BEACON SOLAR ENERGY PROJECT

Supplemental Responses to CEC Data Requests
16; 30 & 32; 101-103, 106-109, 112, 114-115, & 117-123
Docket No. 08-AFC-2

October 23, 2008

Figure DR-102a
Alluvial Thickness for the
Koehn Sub-Basin

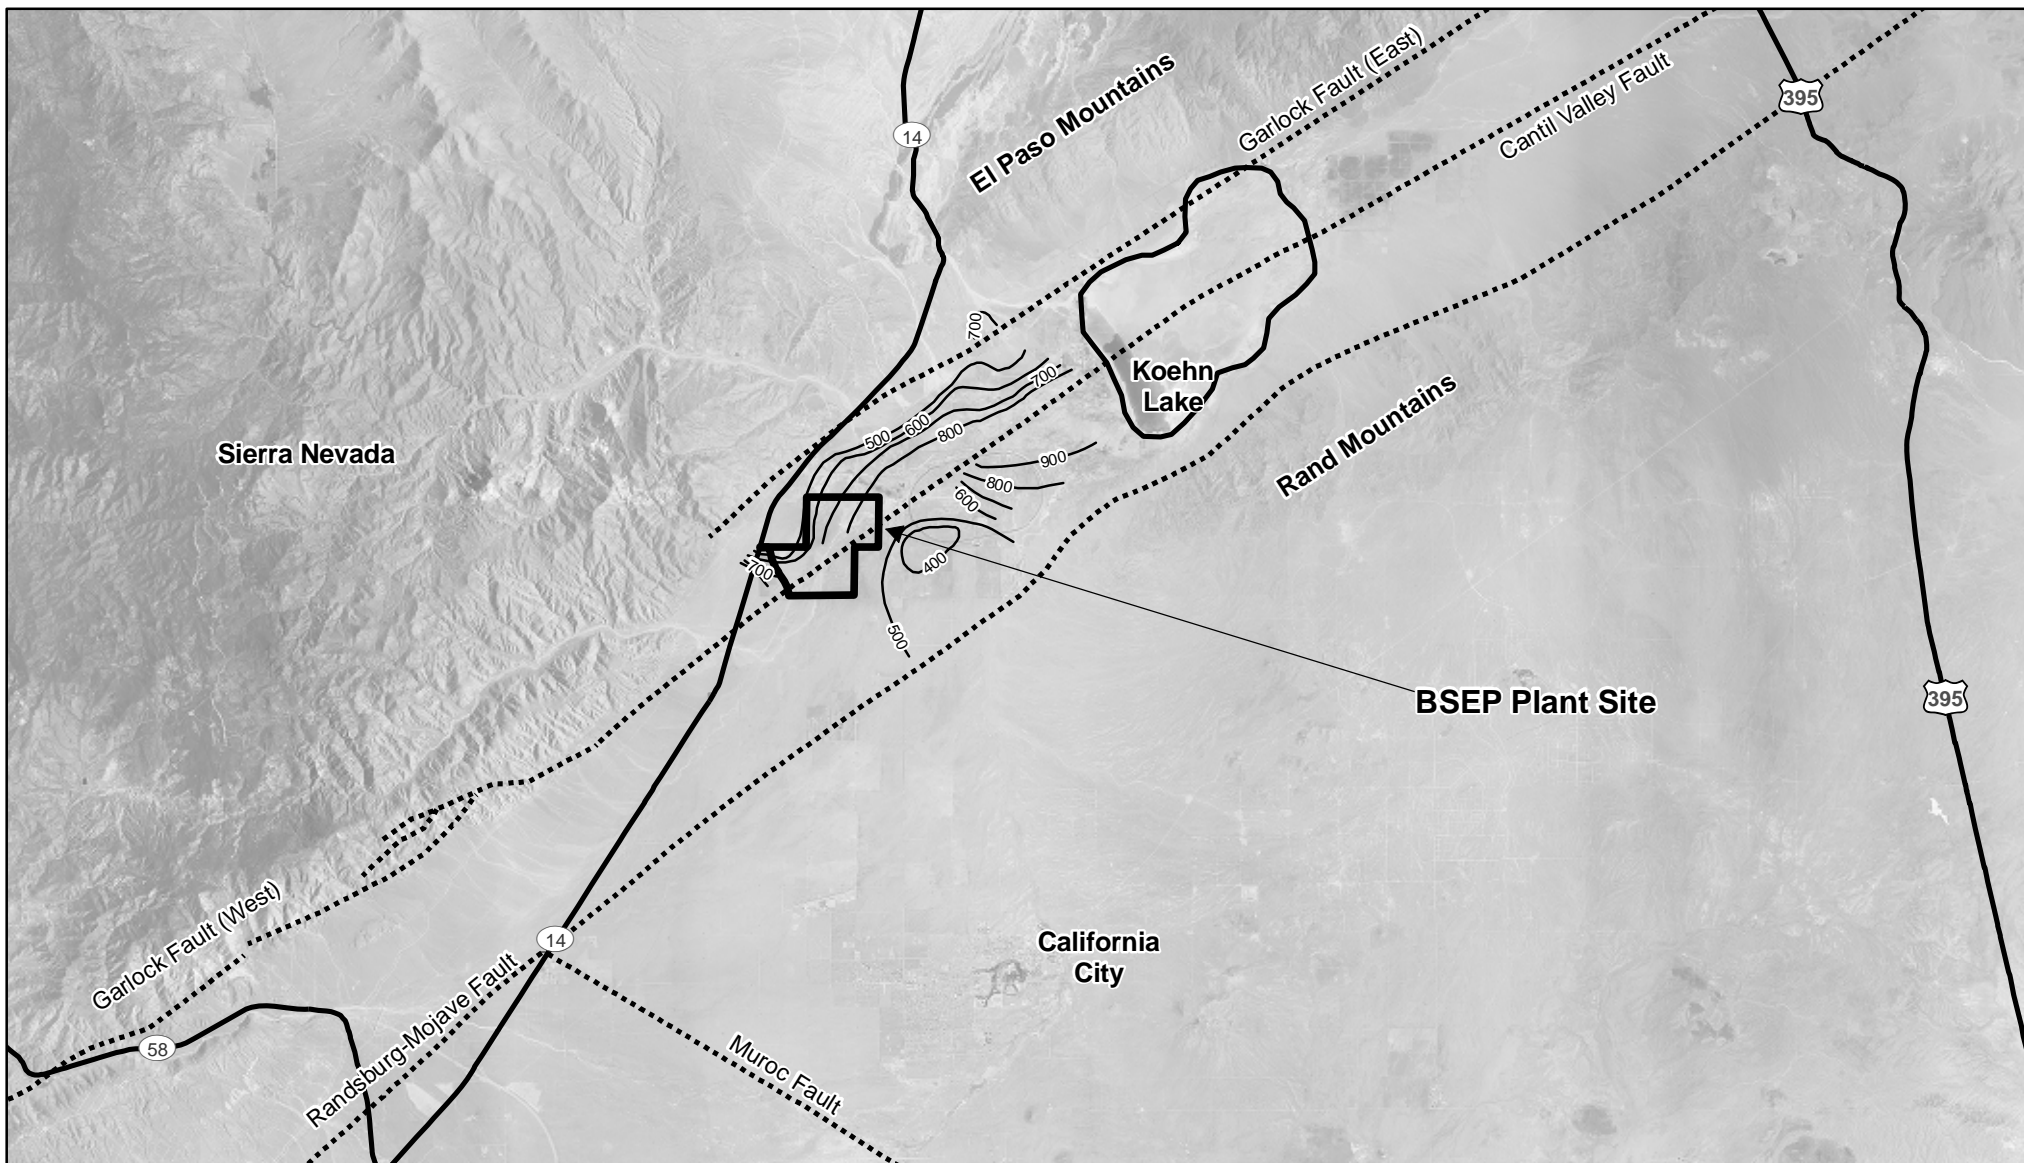
Koehler (1977) states on page 10, "Cantil Valley fault acts as a barrier to groundwater movement". The key figures in Koehler (1977) are Figure 3 (thickness of sediments) (Figure DR-102a, attached), Figure 4 (water levels for 1958) (Figure DR-102b, attached), Figure 5 (water level for 1976) (Figure DR-102c, attached), and especially Figure 6 (water level decline 1958-1976) (Figure DR-102d, attached).

- Sediment Thickness Patterns: Figure DR-102a (sediment thickness) shows that the thickness patterns for the alluvial sediments are much different on the north side of the Cantil Fault than on the south side. On the north side of the fault, the thickness of the sediments increases from around 500 feet near the Garlock Fault to around 800 feet near the Cantil Fault. On the south side of the Cantil Fault, the sediment thickness increases from southwest to northeast toward Koehn Lake, showing no relationship to the Cantil Fault. This pattern of sediment thickness is opposite that found on the north side of the Cantil Fault, suggesting influence of depositional patterns and juxtaposition along the Cantil Fault.

Figure DR-107
Predicted vs. Observed
Water Levels (1958)

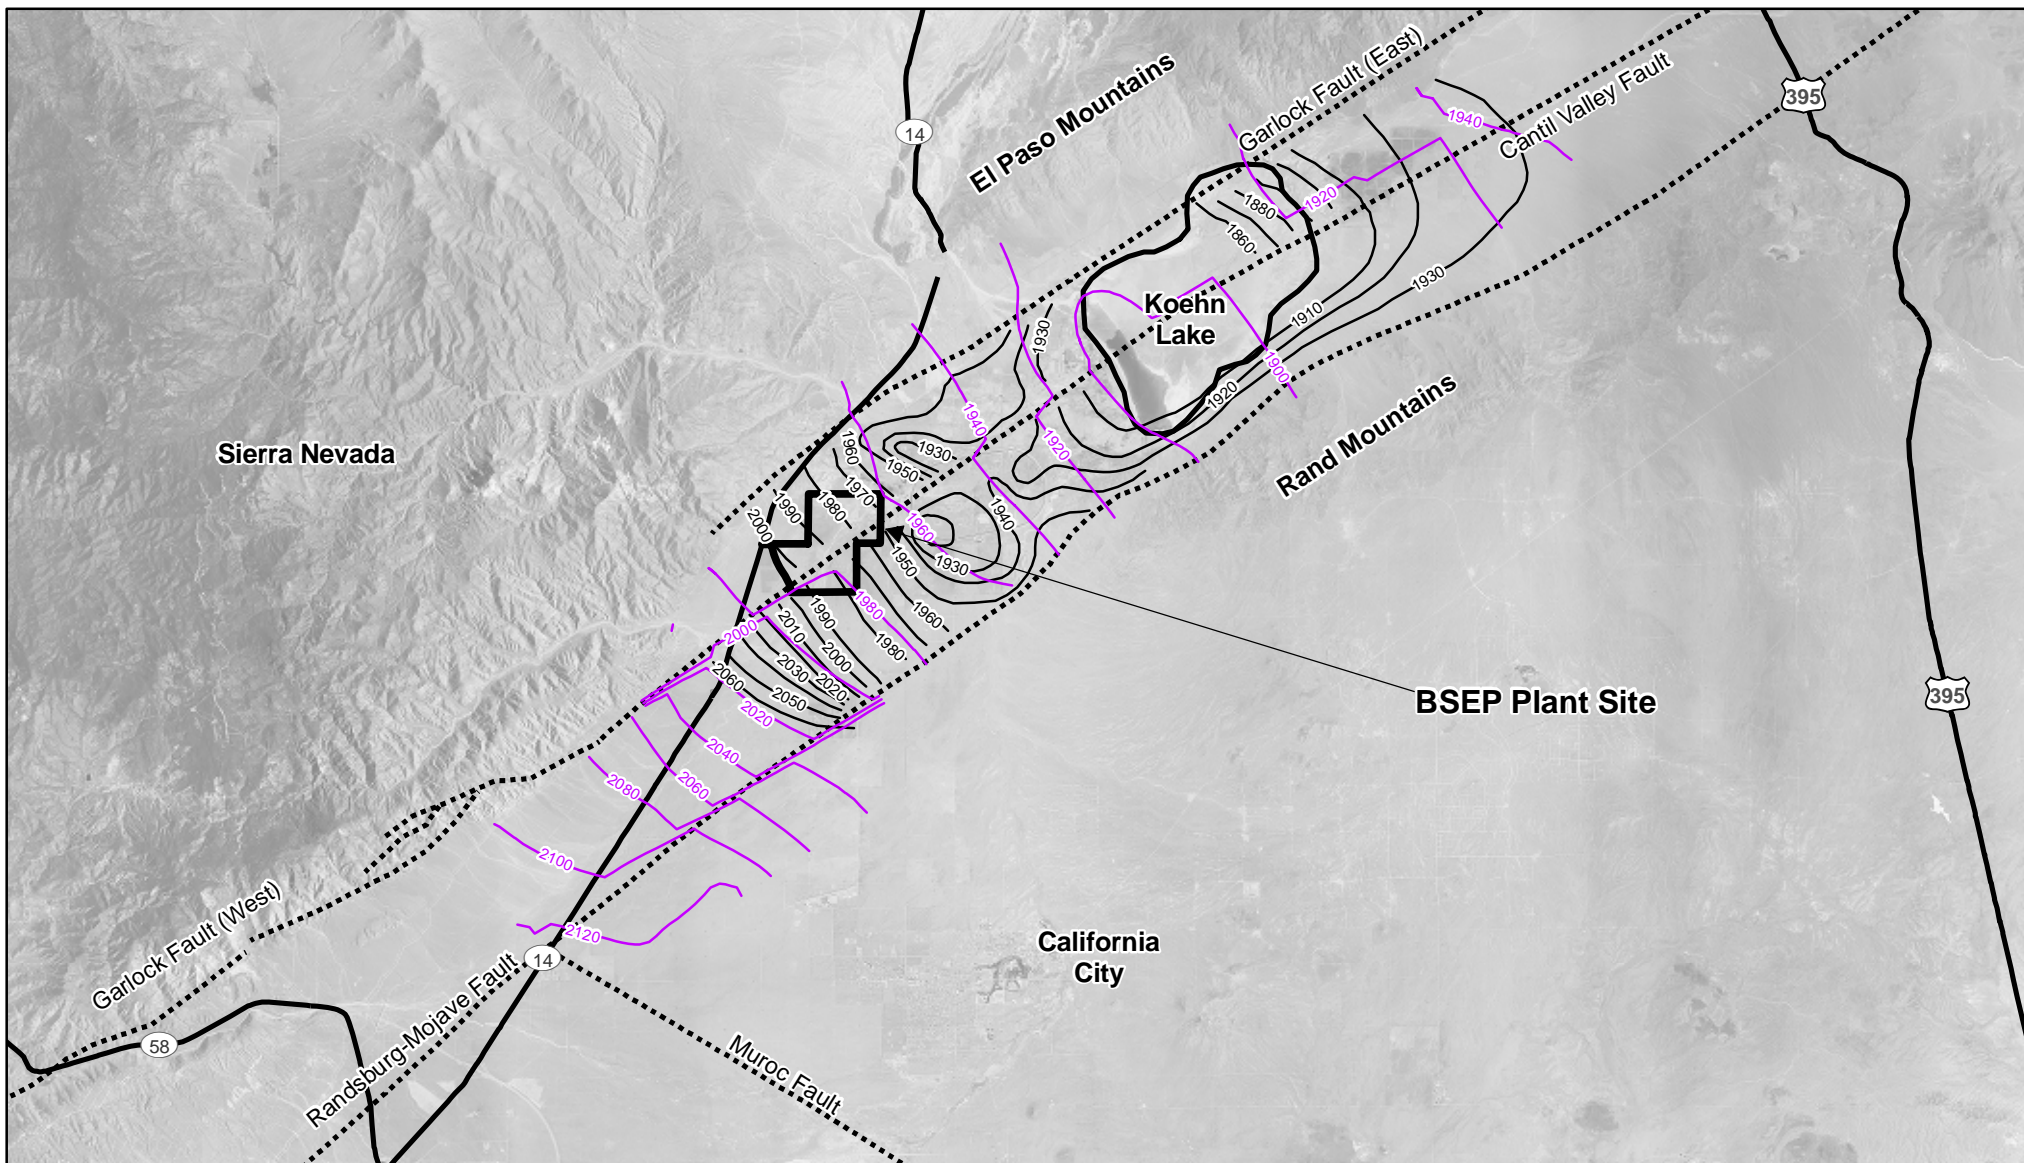
Please provide a map that overlays and compares observed (Figure 3.2) and simulated (Figure 4.6) 1958 groundwater level contours. Figure 4.6 is titled "observed vs. simulated 1958", but there is only one set of contours and the figure does not identify which set is shown (i.e., observed or simulated).

Figure 4.6 in AFC Appendix J.2 was mislabeled. The figure shows the calibrated water level contours for 1958. Figure DR-107 shows the observed water levels for 1958 (Figure 3.2 or DR-102b, attached) in comparison to the predicted water levels from the groundwater model for 1958 (Figure 4.6).

Figure DR-108
Predicted vs. Observed
Water Levels (1976)

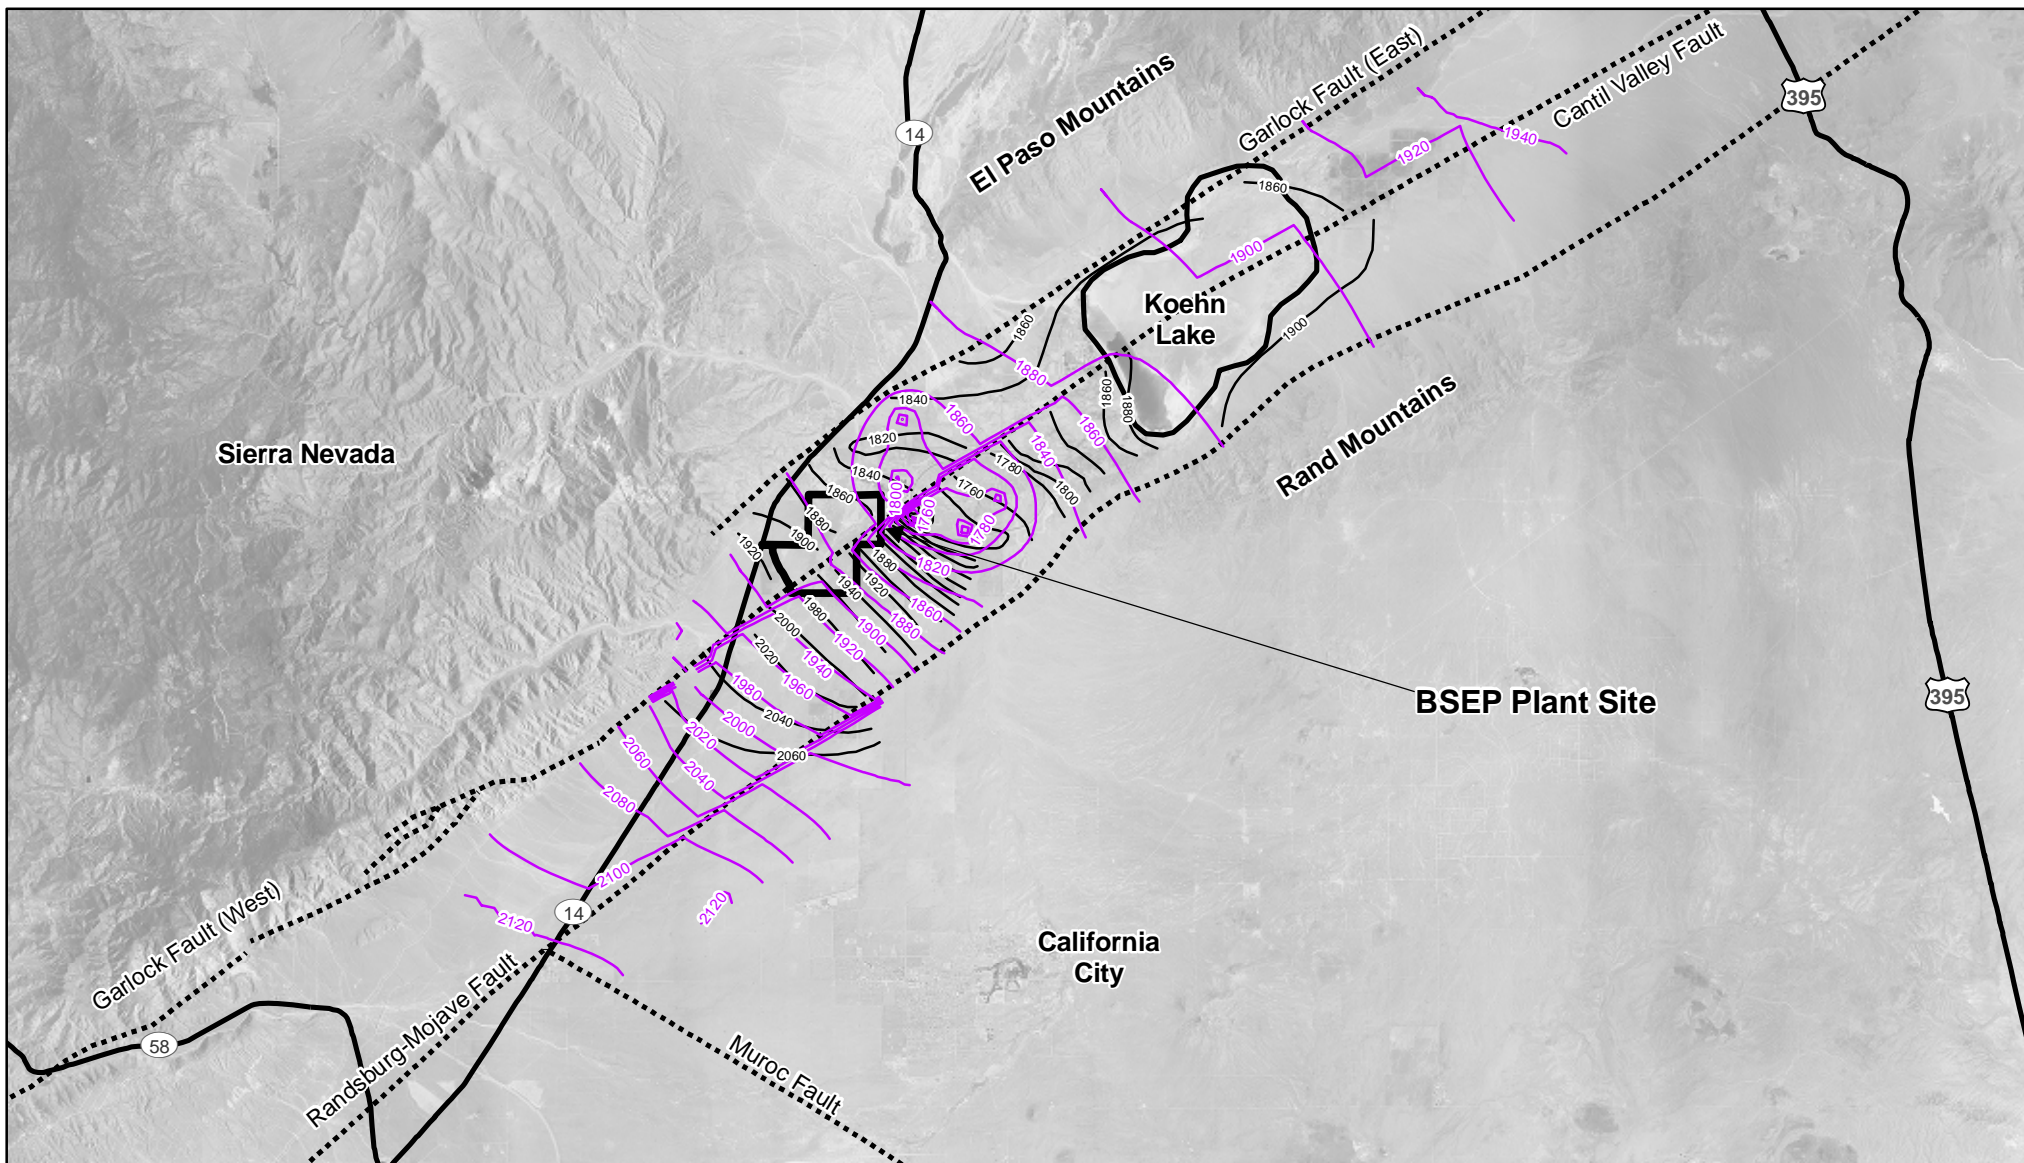
Please provide a map that overlays and compares observed (Figure 3.4) and simulated 1976 groundwater level contours.

Attached is Figure DR-108, showing the observed (Appendix J.2 Figure 3.4) water levels for 1976 and the predicted water levels from the groundwater model.

Figure DR-109
Predicted vs. Observed
Water Levels (2007)

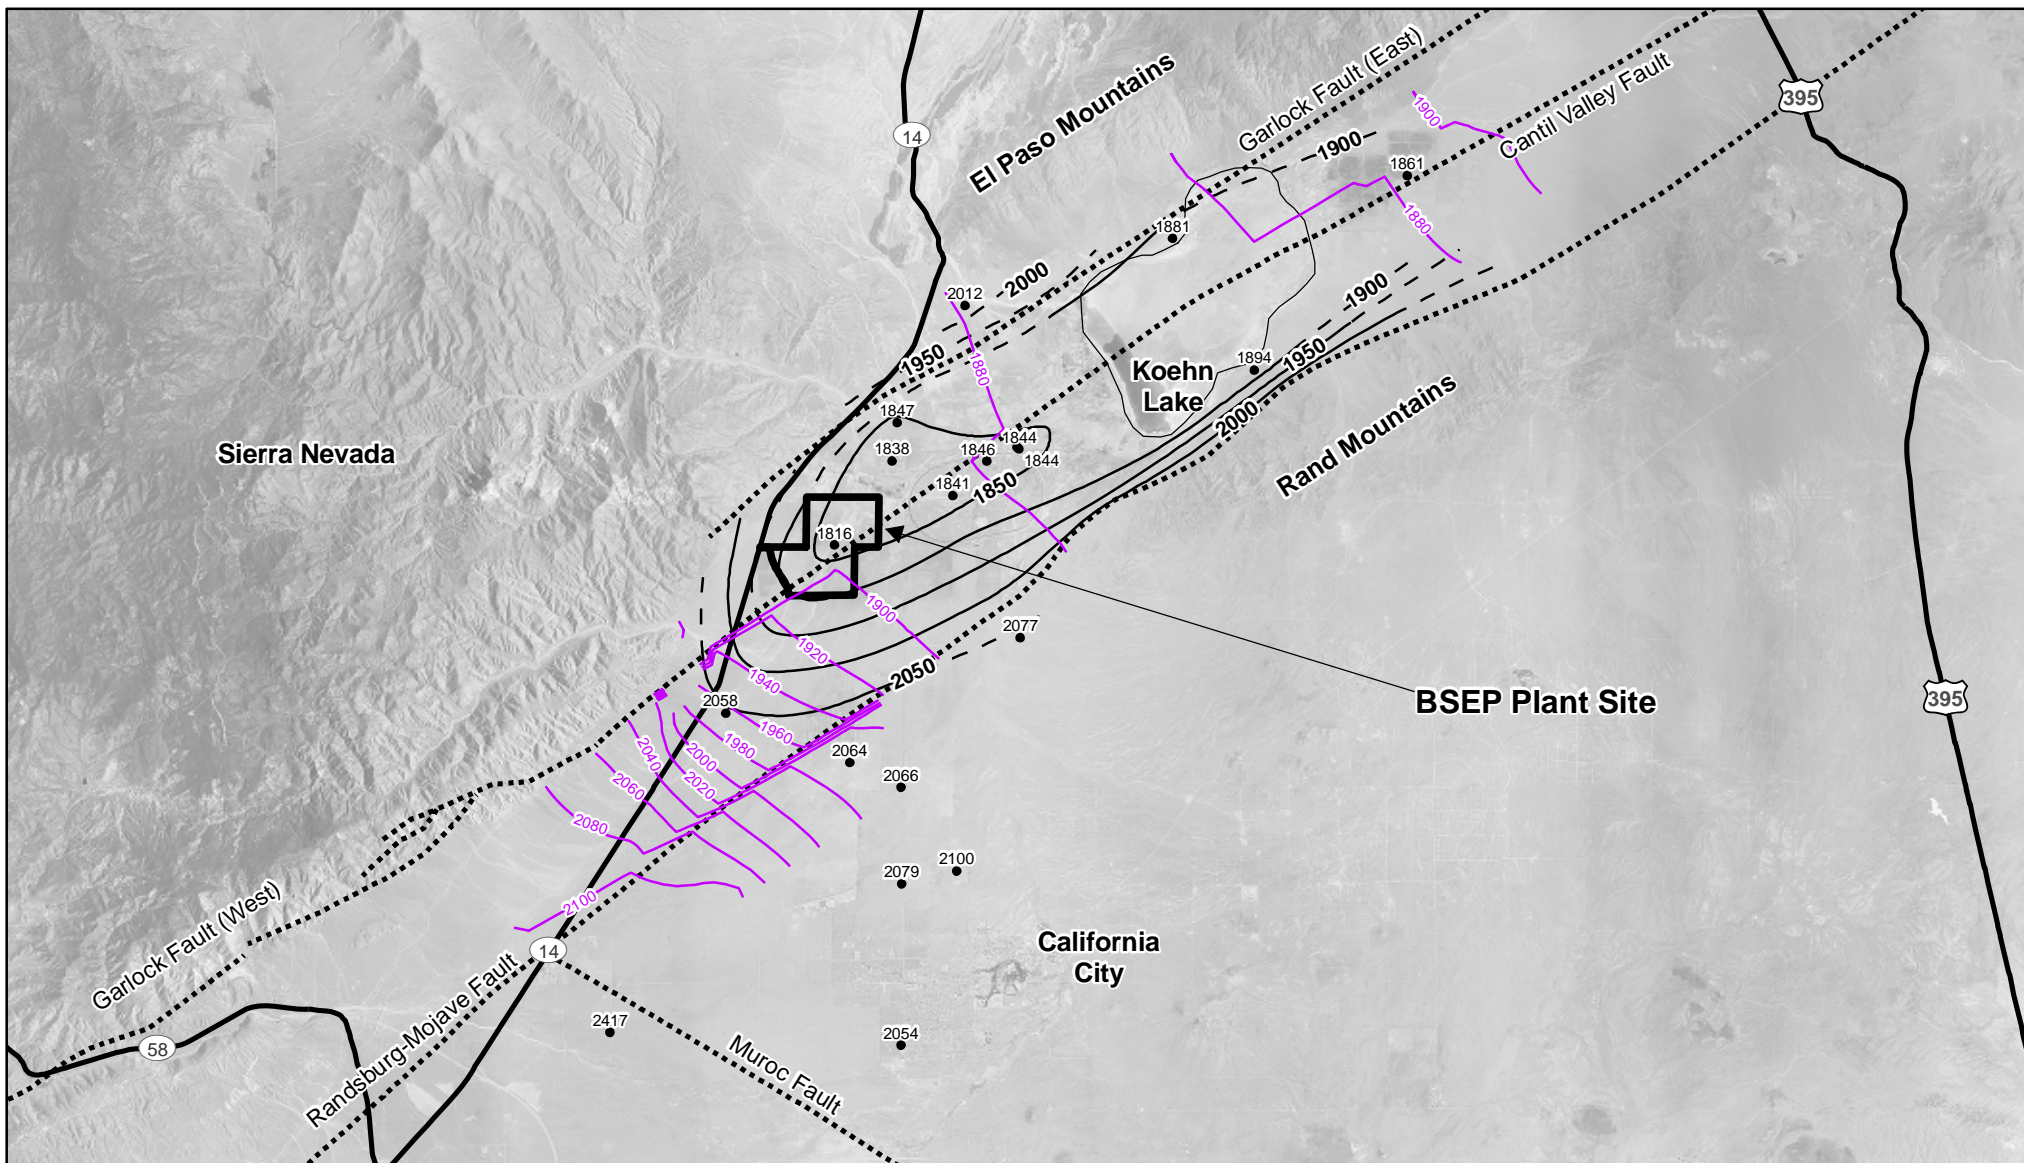
Please provide a map that overlays and compares observed (Figure 5.17-3) and simulated 2007 groundwater level contours.

Attached is Figure DR-109, showing the observed water levels for 2007 and the predicted water levels from the groundwater model for 2007.
